ADDENDUM

PROJECT	NKU New Residence Hall	ADDENDUM NO.	3
PROJECT NO.	18237.01	DATE	02/21/2020
TO	Brian Groneck	FROM	Dan Bossenbroek

VERTICAL METAL PANEL & STOREFRONT @ INTERMEDIATE FLOORS

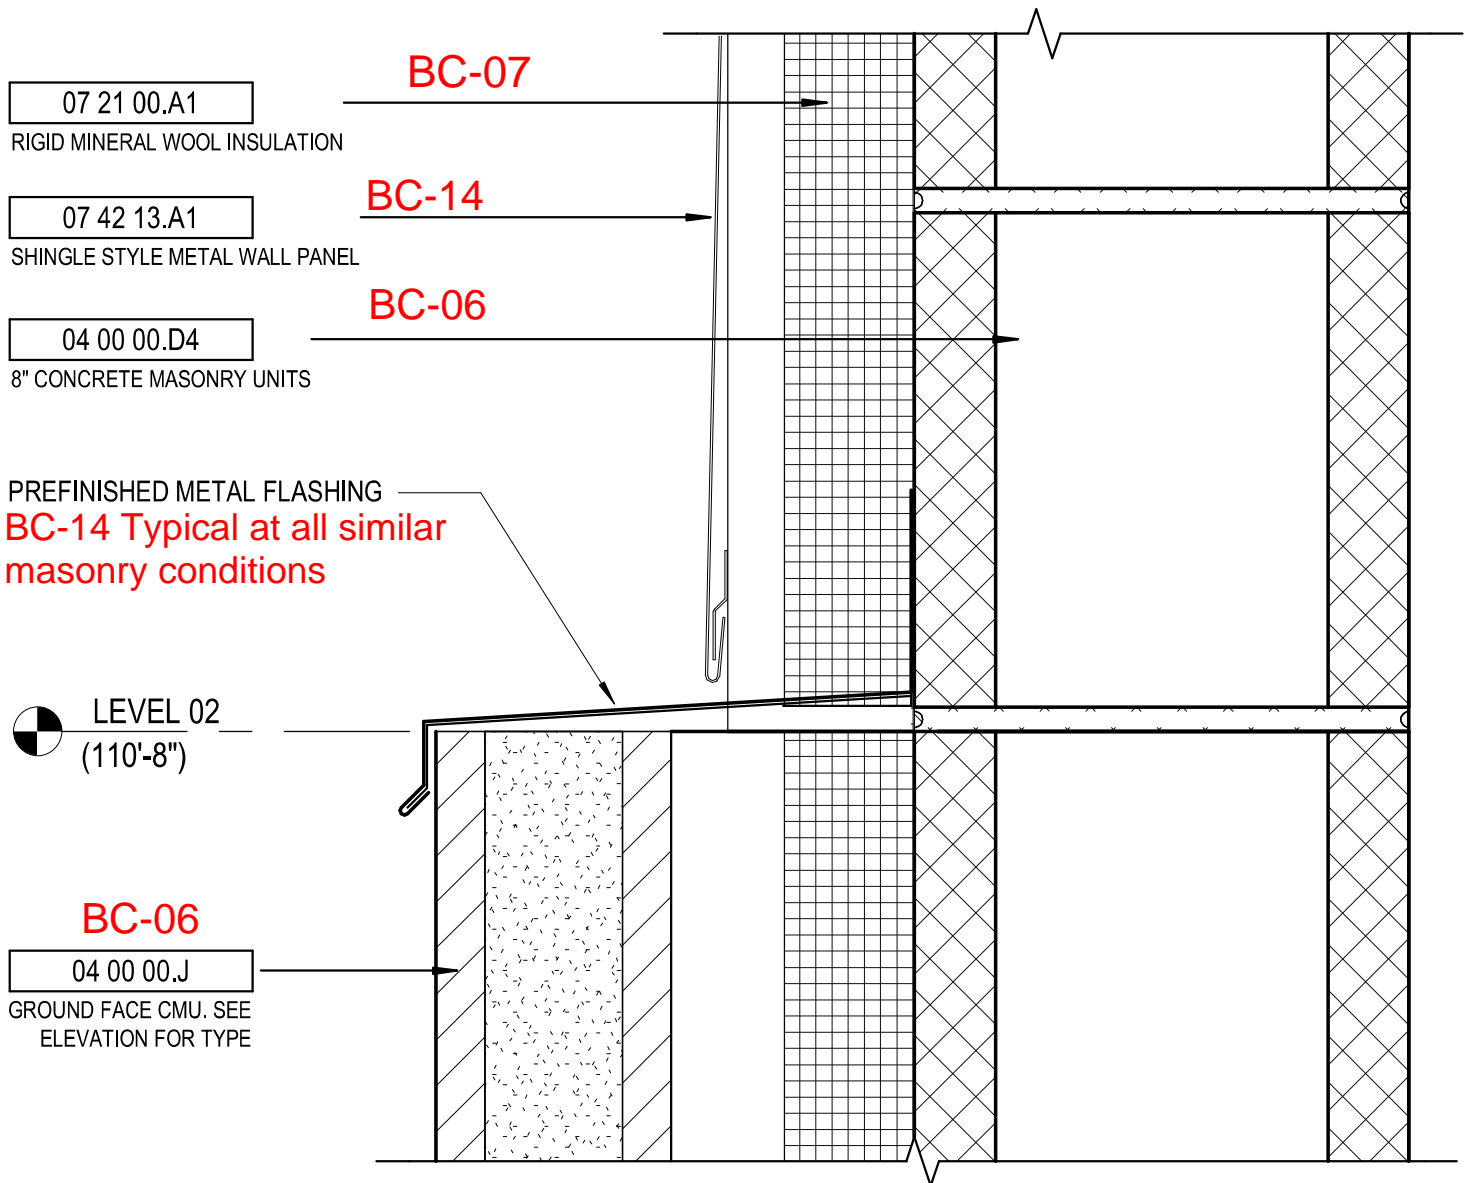
- A) Revised Details 6, 11, 12, 13, 18 & 19.
- B) Deleted Details 7 & 8.

TYP. FOUNDATION AT NORTH WALL

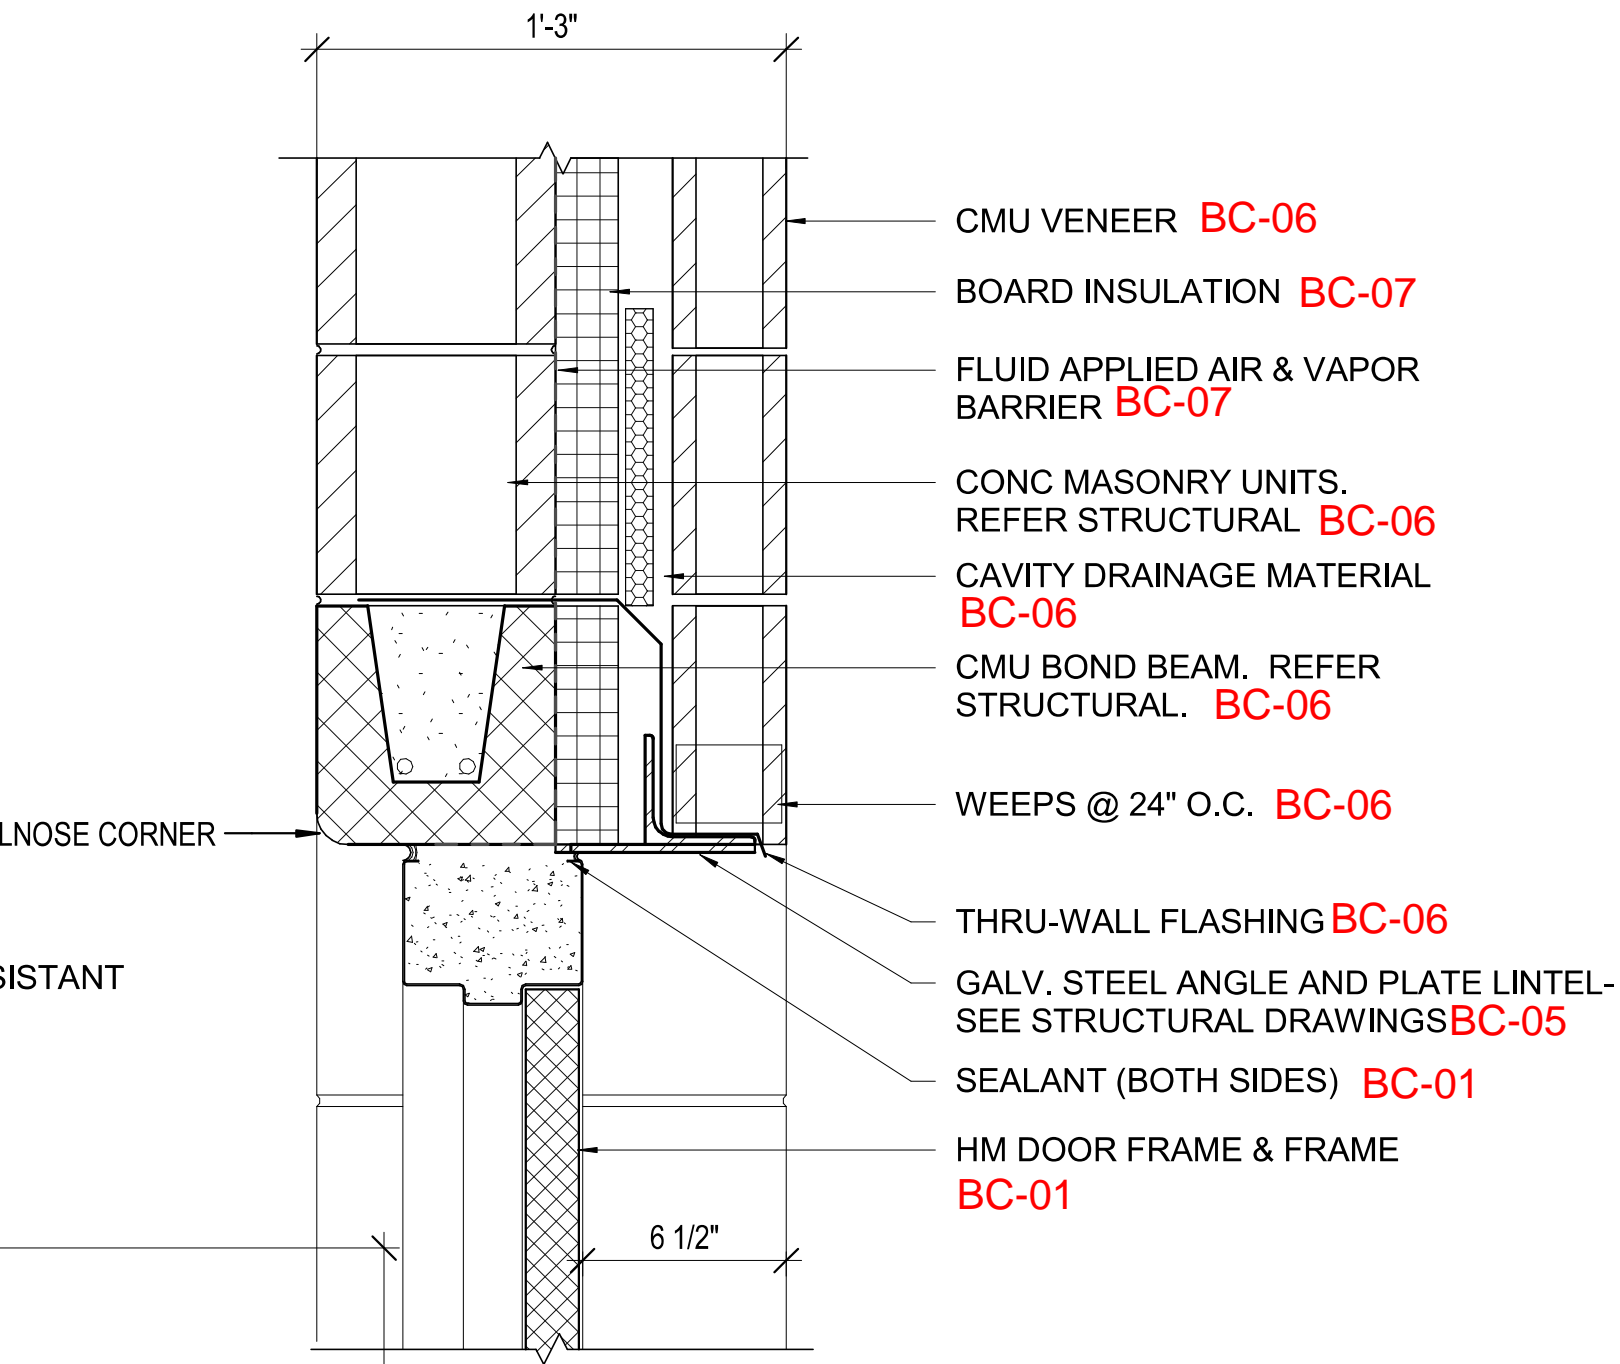
- A) Revised Details 1, 5, 11, 14, & 15.

DRAWING TITLE:
ROLLER SHADE LOCATION
DIAGRAM

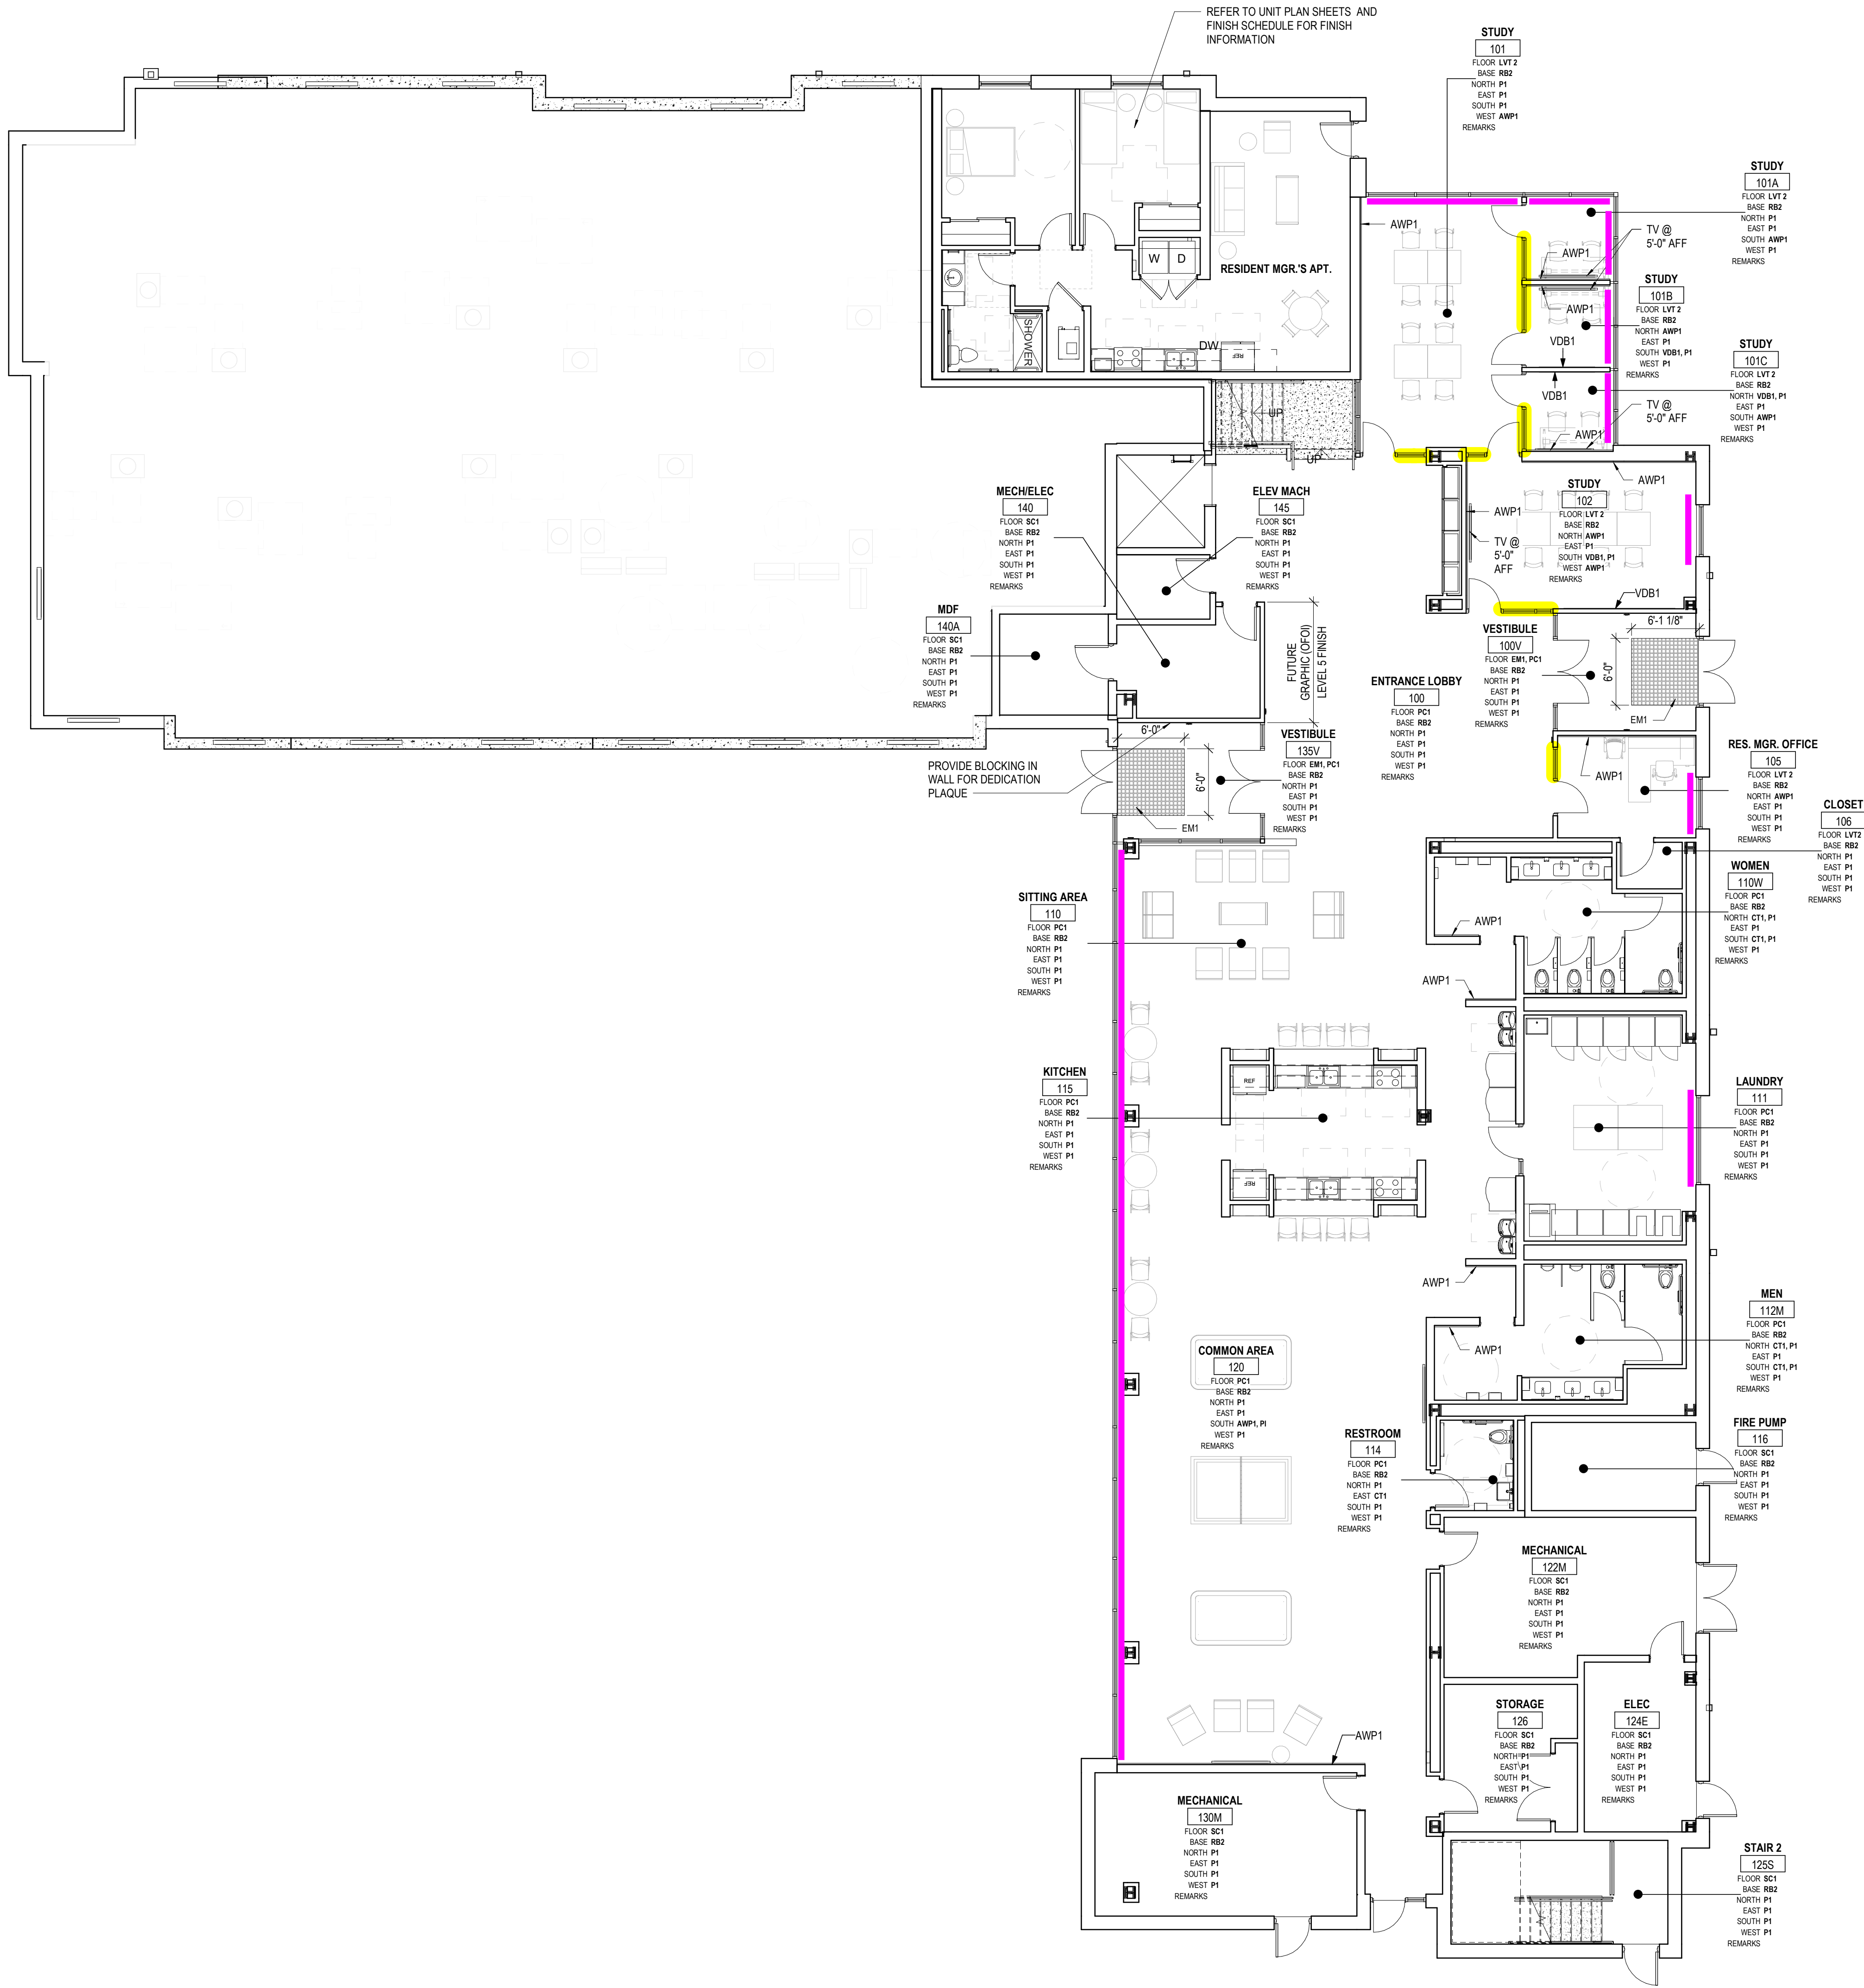
- F) Add Note 8. On 00 24 13 – 79/80: This scope includes roller shades per the RS01 and RS02 drawings provided with Addendum No. 3.

- PROPOSED LOCATION OF ROLLER SHADES
- CURRENTLY NOTED AS GLASS TO RECEIVE PRIVACY FILM IN THE FUTURE

ROLLER SHADE LOCATION
DIAGRAM

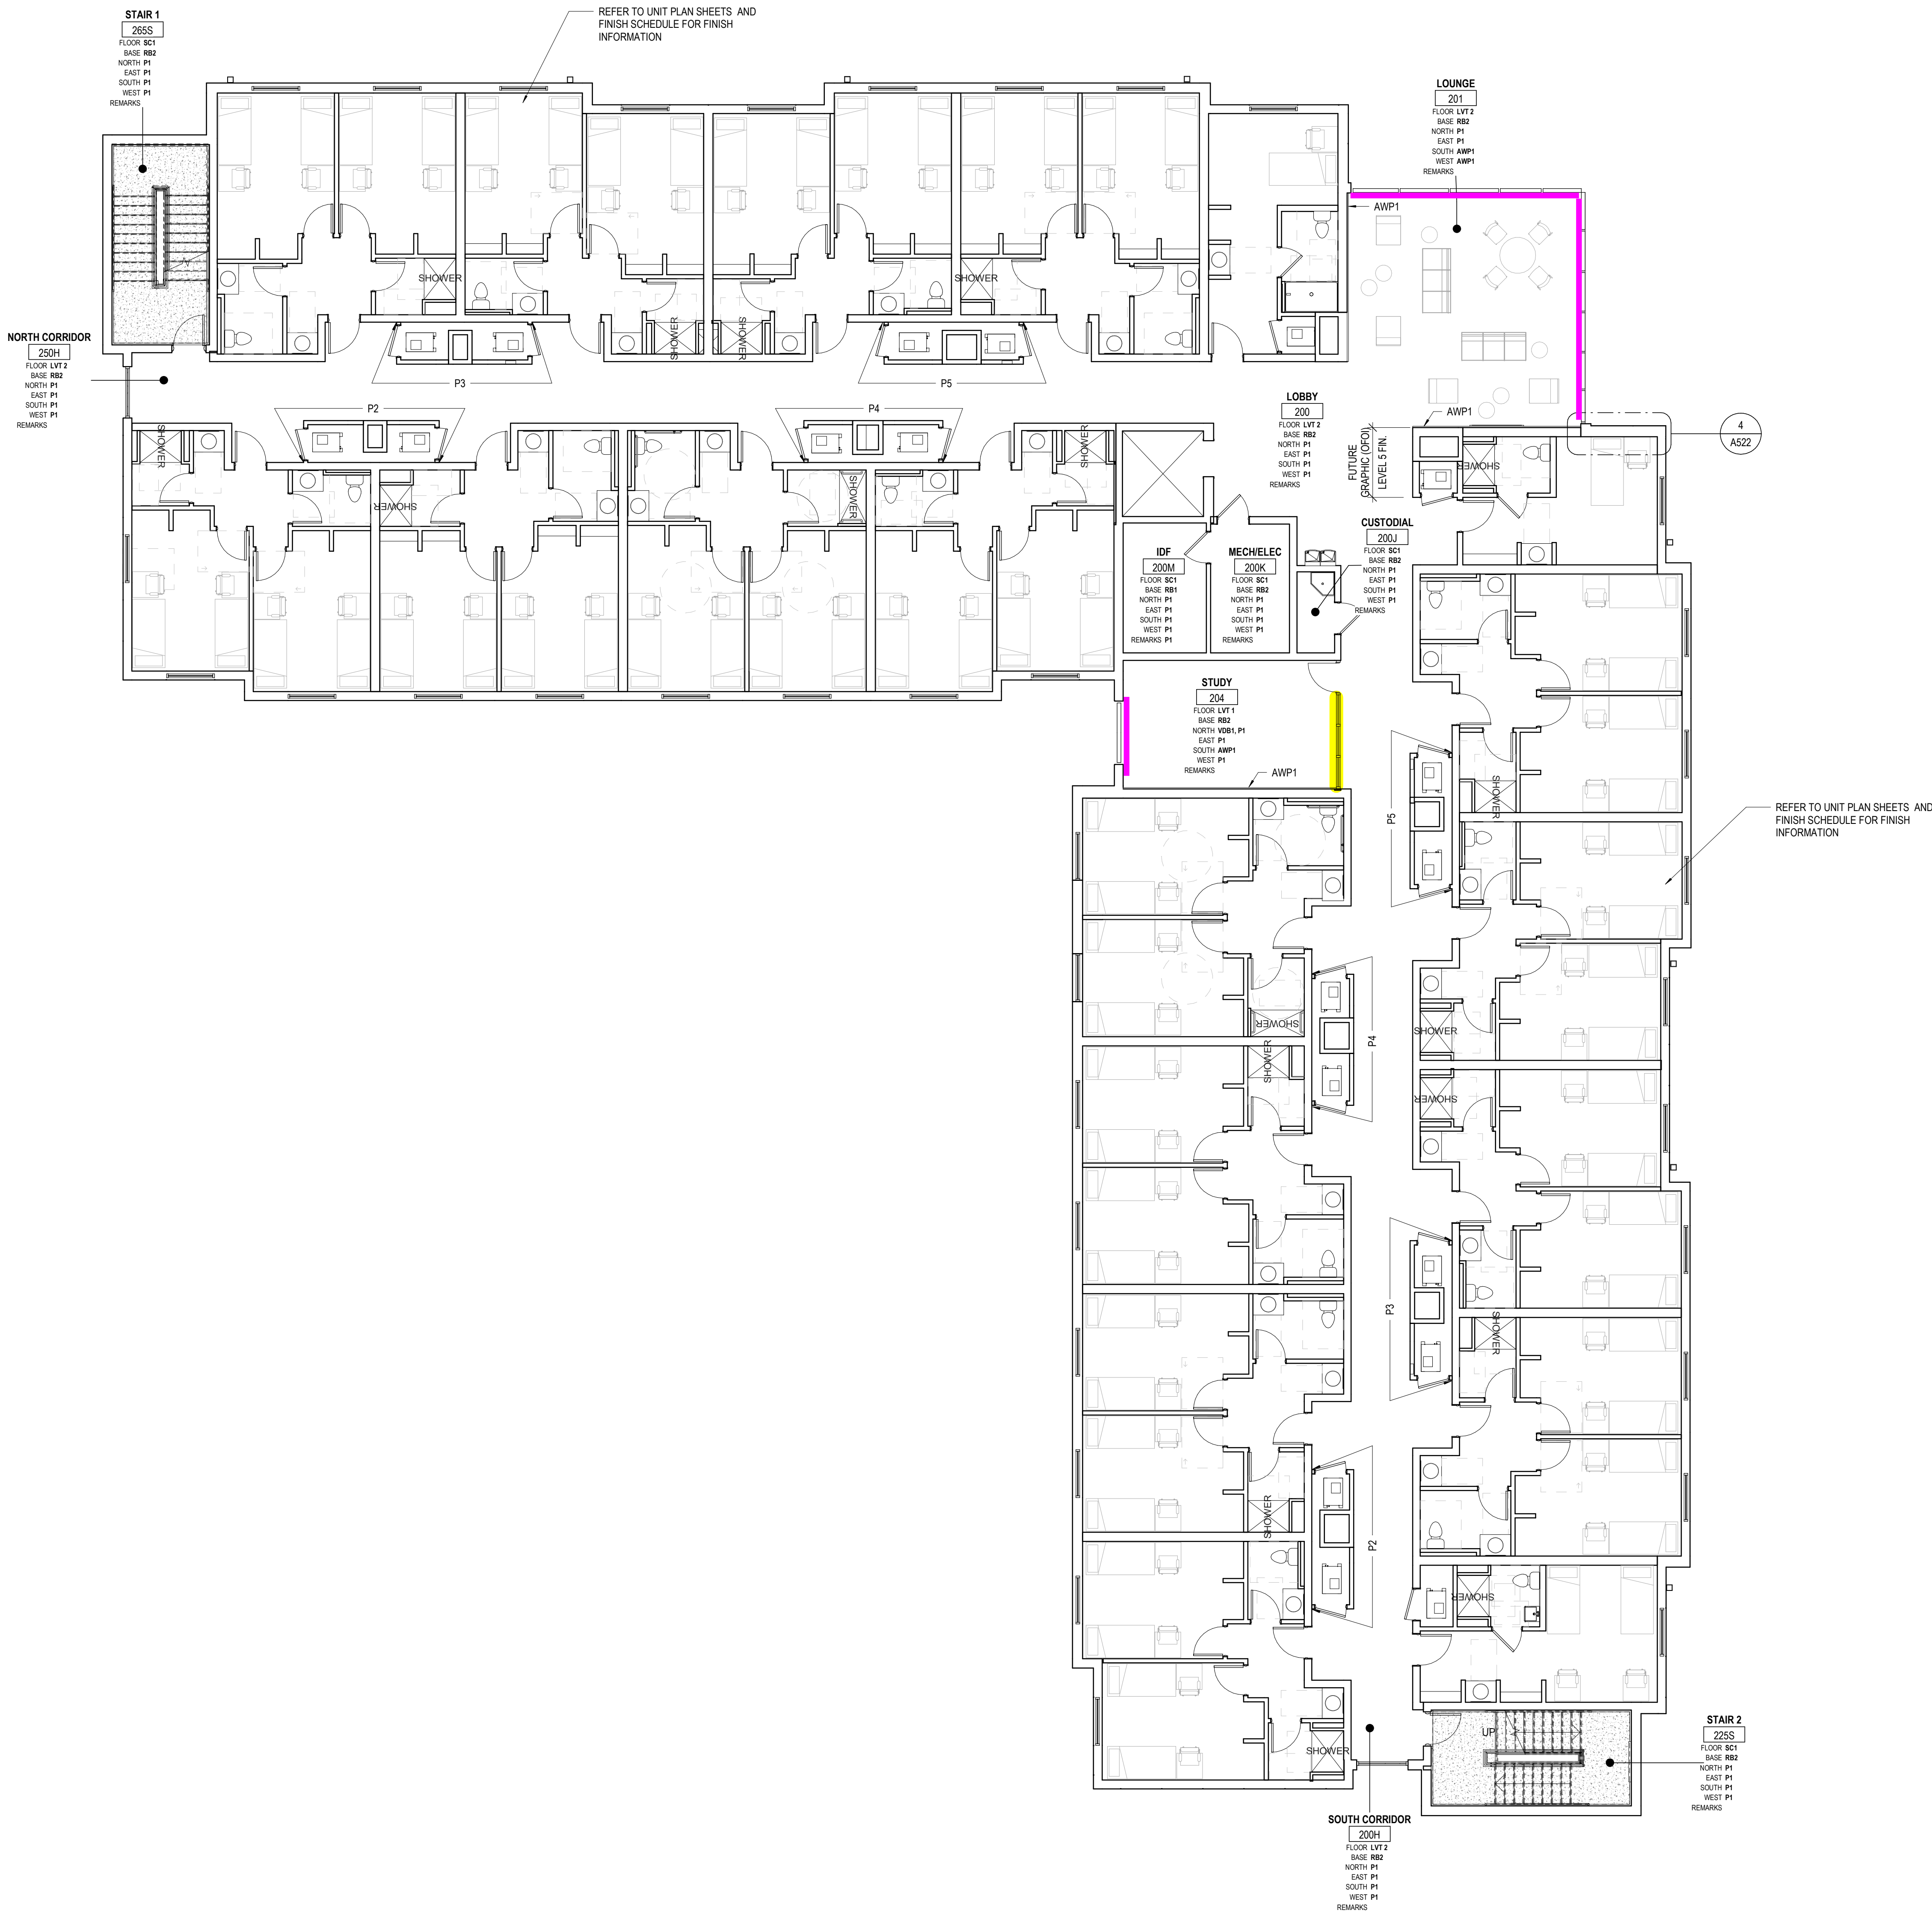
- PROPOSED LOCATION OF
ROLLER SHADES
- CURRENTLY NOTED AS GLASS
TO RECEIVE PRIVACY FILM IN
THE FUTURE
